Quality Control Report

Consultant **Wahib Medanat** Consultant Engineers
Site Name **Um Al Dananir Basic Mixed - Balqa**
Package **Package 1**
Contractor **Derar Saraireh & Sons for Engineering & Contracting**
Tender No. **1/2020/USAID/SKEP/3/1**

Rep No. **QC-11 19**
Date **21 / 05 / 2022**

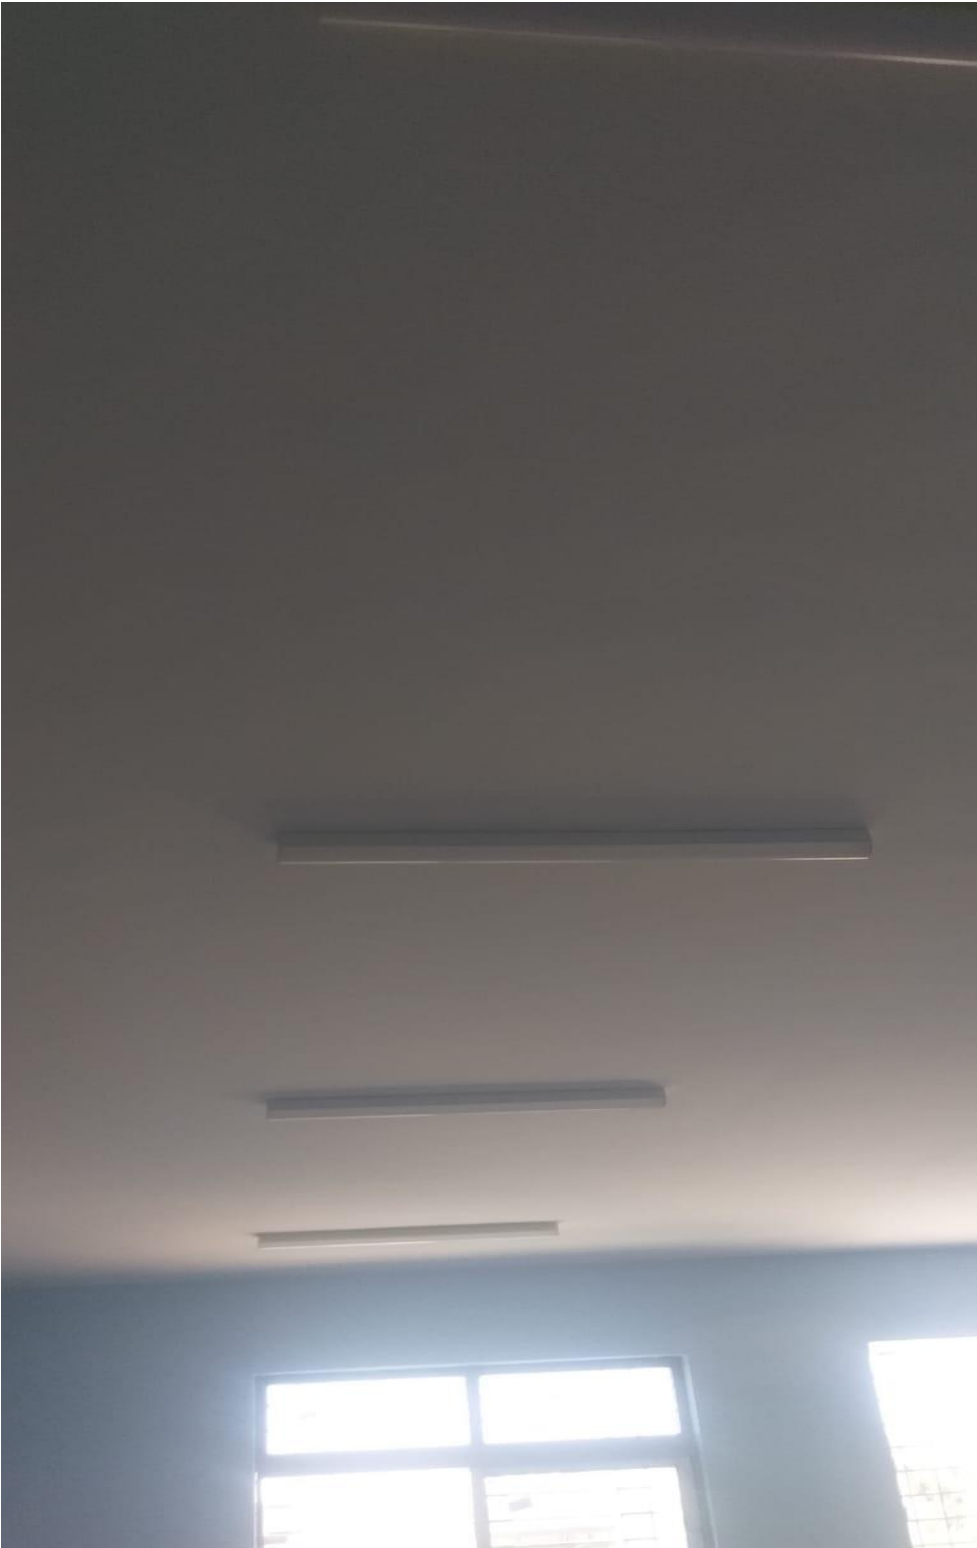
Wider gaps at the tiled wet areas

Smaller dimension for aluminum section

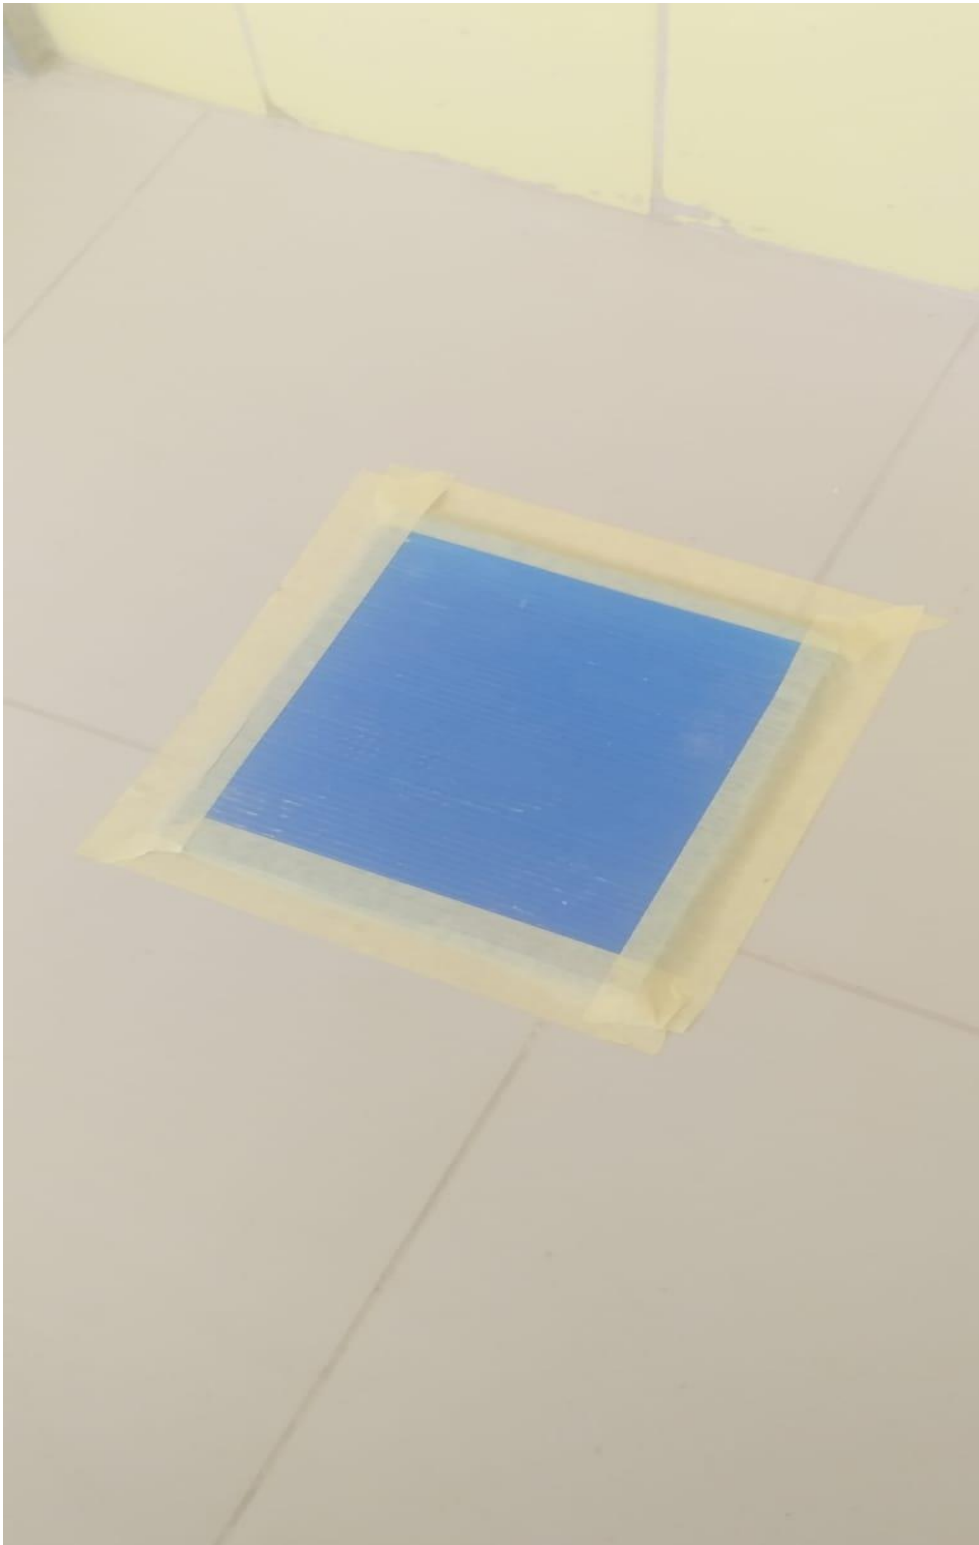
Broken edges of granite

Removing of defected granite tiles
